DEVIATION REQUEST AND DECISION FORM

Project Name : Sterling Ranch East, Filing No. 1, Phase A, Part 1

A deviation in ECM D.4.1.F is requested to use a composite section of asphalt and cement treated subgrade (CTS) as opposed to a composite section of asphalt over aggregate base course.

SITE AND EXPLORATION PLAN
STERLING RANCH EAST F1, PHASE A, PART 1
CLASSIC COMMUNITIES

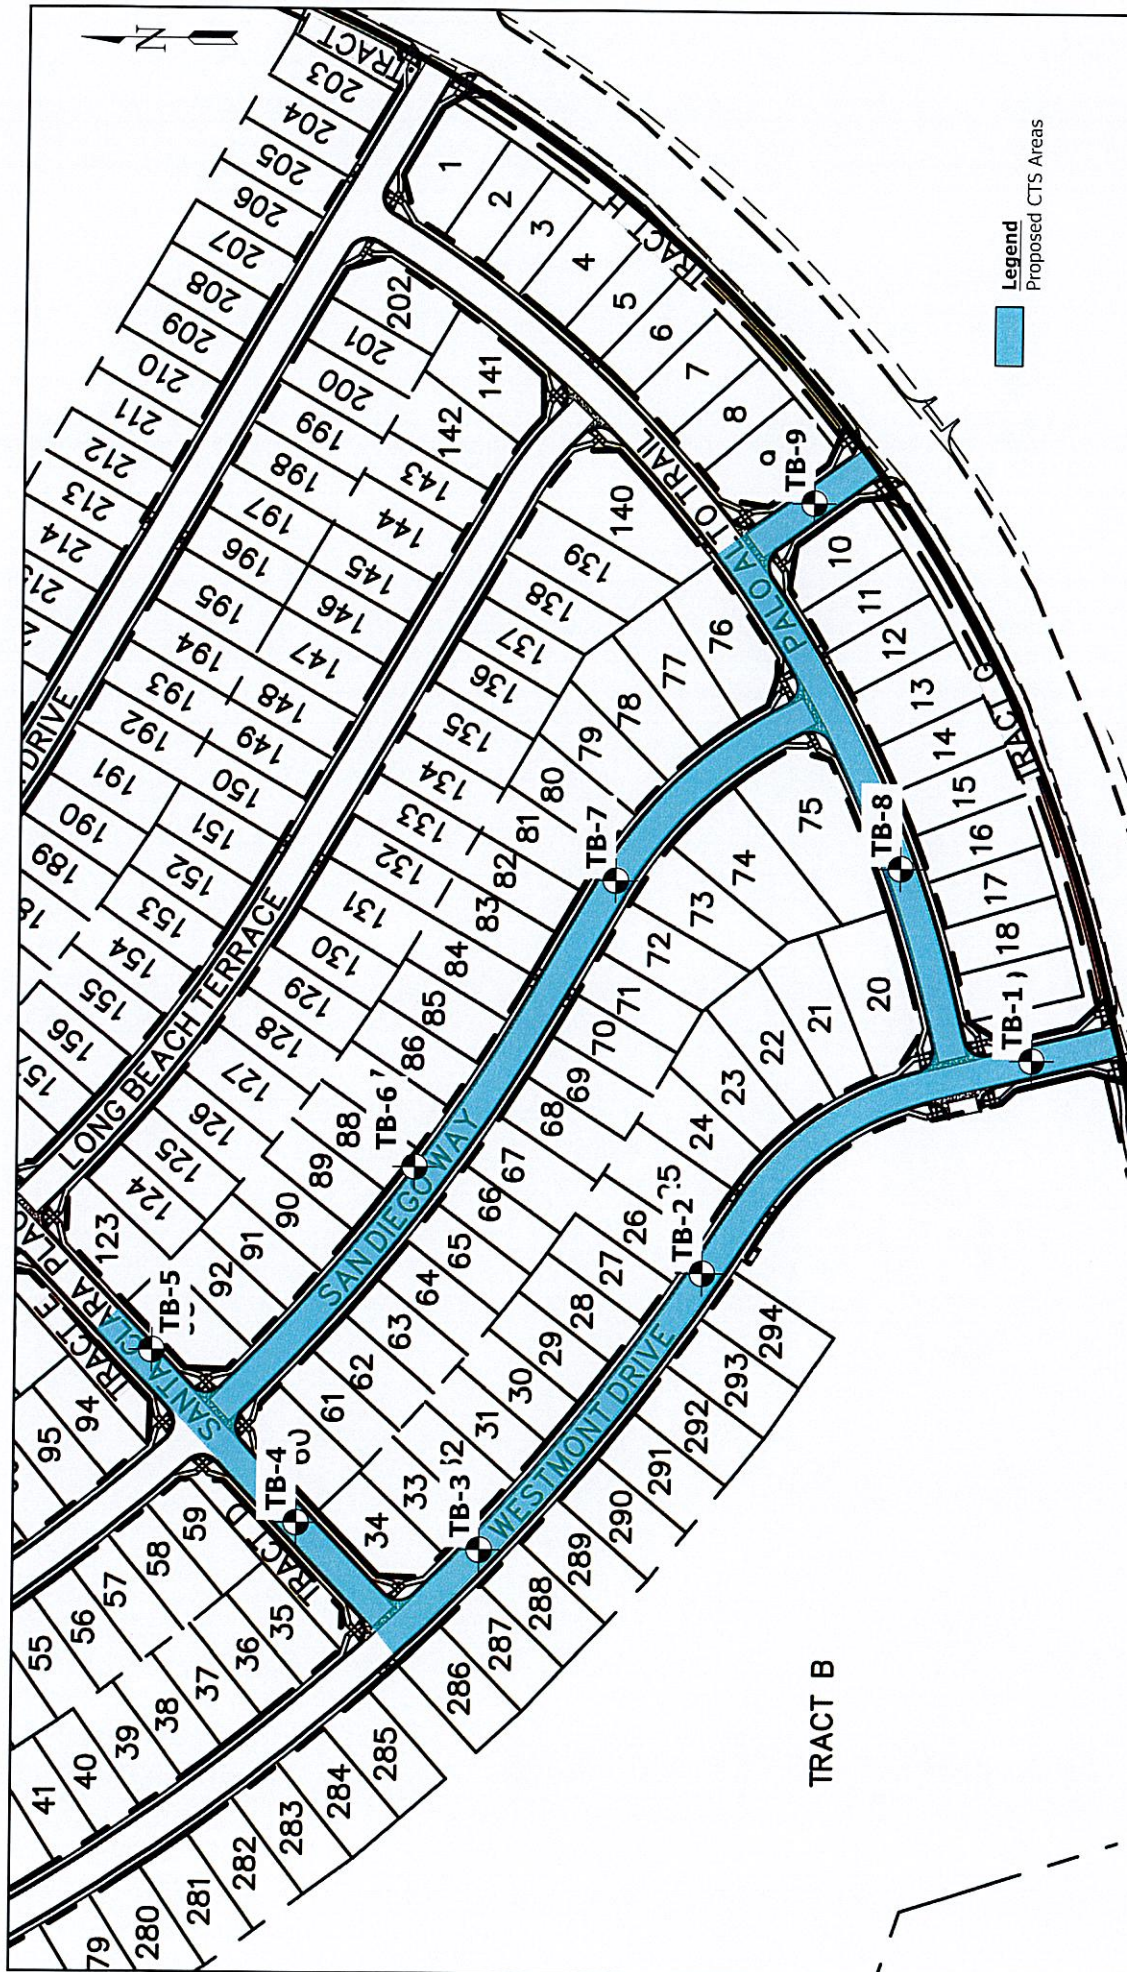
The development filing is Sterling Ranch East Filing No. 1, Phase A, Part 1. The roadways included are Palo Alto Lane, Westmont Drive, San Diego Way, and Santa Clara Place the limits are shown in the attached figure.

An exhibit displaying the areas to include CTS is attached with this deviation request.

This request has been determined to have met the criteria for approval. A deviation from Section D.4.1.F of the ECM is hereby granted based on the justification provided.
